Overheating - 1988 Sea Ray 135 and 175

1988 Sea Ray 135 and 175 s/n 0B241881 thru 0C100861

Figure 1. Top View Of Cowl Mounting Plate

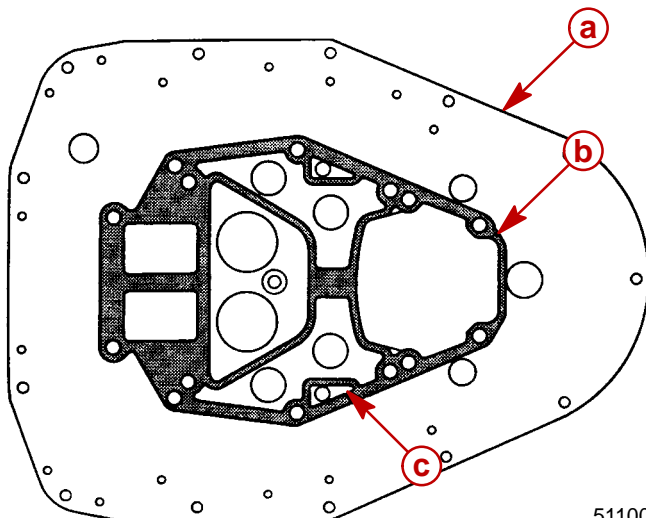
Some 1988 Sea Ray V135 and V175 outboards with oyster colored bucket cowls may experience an overheating condition. This condition may occur on outboards that are operated for long periods of time at full throttle in warm water. The overheating condition may be caused by restrictive water dump hole in the cowl mounting plate p/n 18103.

If overheating persists, modification of the cowl mounting plate is required. Use the gasket p/n 27-99776--1 as a template and scribe the triangular water dump hole opening on to the starboard side of the plate as shown in figure 1. Open the hole to the scribed line and deburr the plate (figure 2). Reassemble with new gaskets on both sides of the plate. This modification will increase water flow and reduce water pressure at 2500 RPM from 12 psi (83 kPa) to approximately 8 psi (55kPa).

- a** - Cowl Mounting Plate
- b** - Gasket
- c** - Enlarge Hole to Triangle Shape
